REMARKS/ARGUMENTS

Appl. No.: 10/618,223
Filed: 07/11/2003
Amdt. dated 01/17/2006

2/15

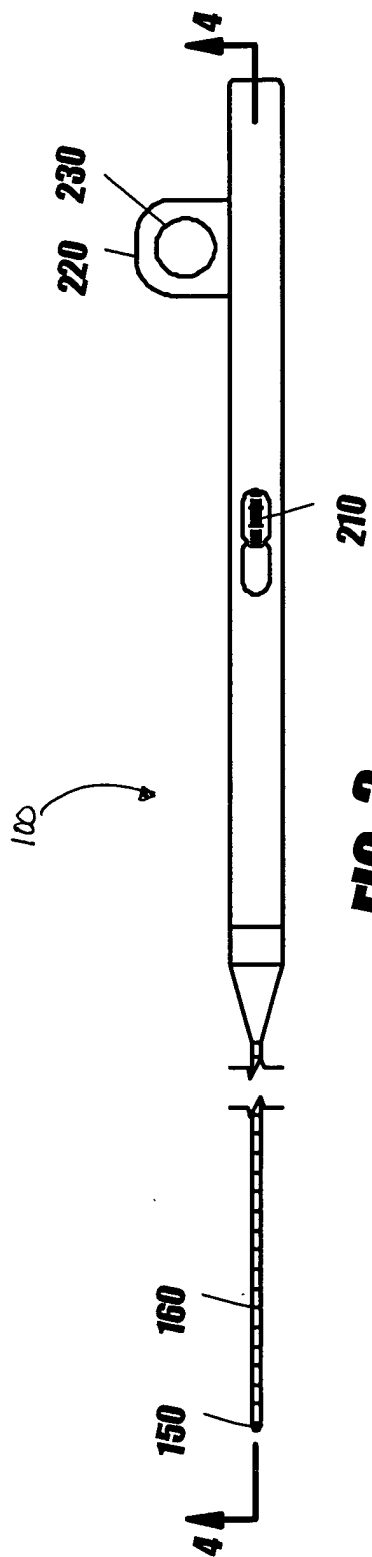
The drawings were objected to for lacking the reference sign 100. The reference sign 100 refers to the lumen measuring device and has been added to various figures and submitted for approval.

100
